A-071-G TO MBB-071 BRACKET TRANSITION

A-081-G TO MBB-081 BRACKET TRANSITION

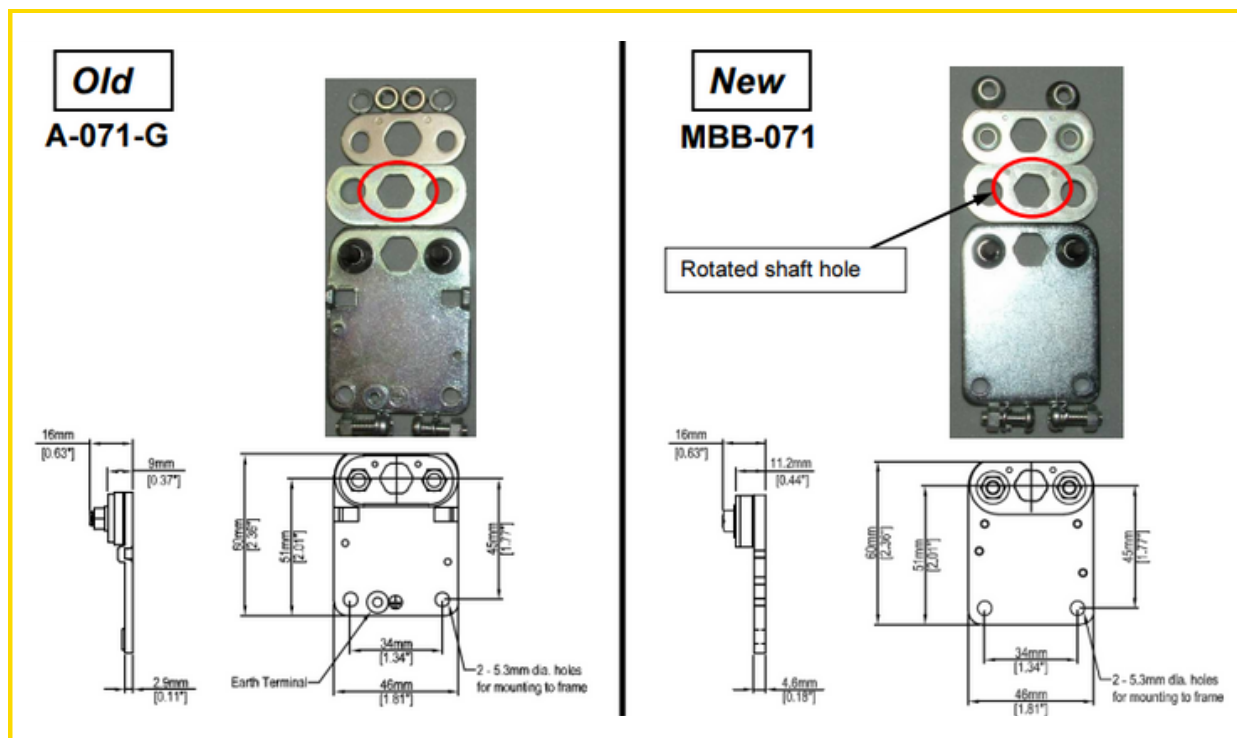
Notice: The A-071-G bracket has been replaced by the MBB-071. The A-071-G will no longer be available to purchase. The MBB-071 will be available for both new applications and replacements of the A-071-G.

Reason for change: The MBB-071 is a universal mounting bracket that will become the standard for all DC rollers that have a plain 7/16" Hex shaft.

Features: The shaft hole of the middle mounting plate is rotated a few degrees which grips the shaft securely once the top plate and nuts are tightened to the correct torque.

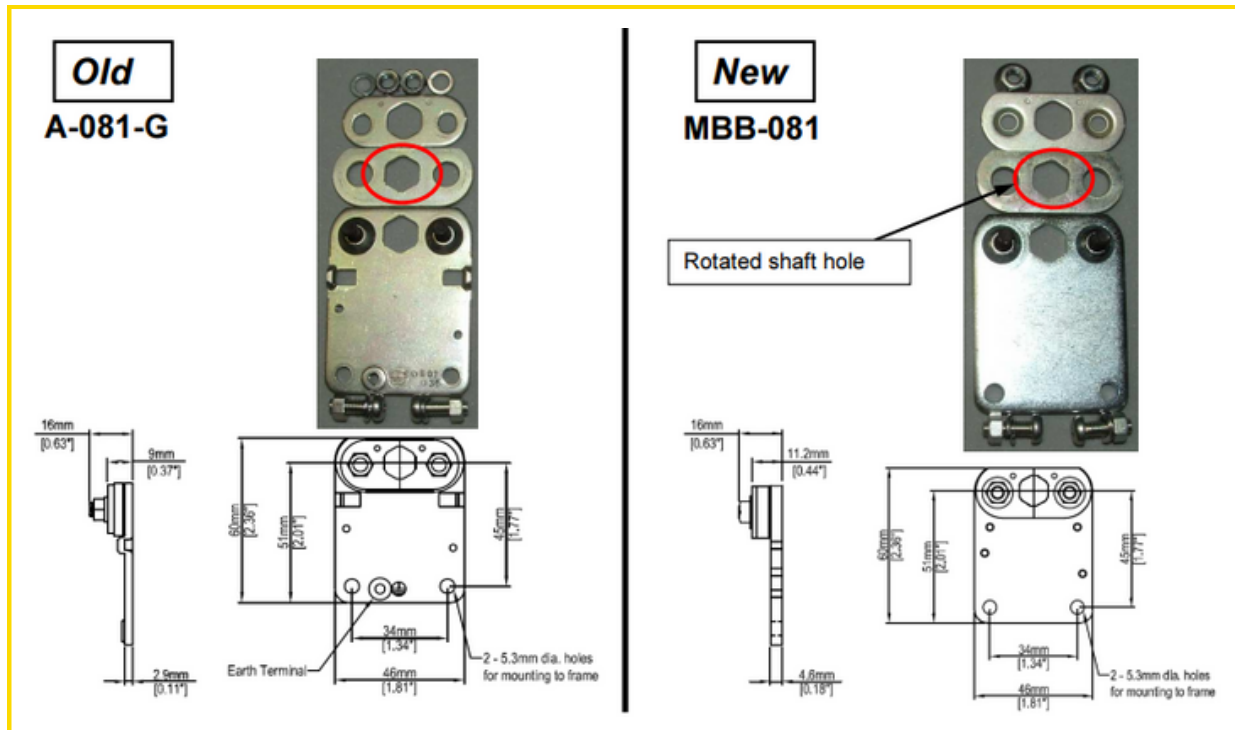
Notice: The A-081-G bracket has been replaced by the MBB-081. The A-081-G will no longer be available to purchase. The MBB-081 will be available for both new applications and replacements of the A-081-G.

Reason for change: The MBB-081 is a universal mounting bracket that will become the standard for all DC rollers that have a plain 7/16" Hex shaft.

Features: The shaft hole of the middle mounting plate is rotated a few degrees which grips the shaft securely once the top plate and nuts are tightened to the correct torque.
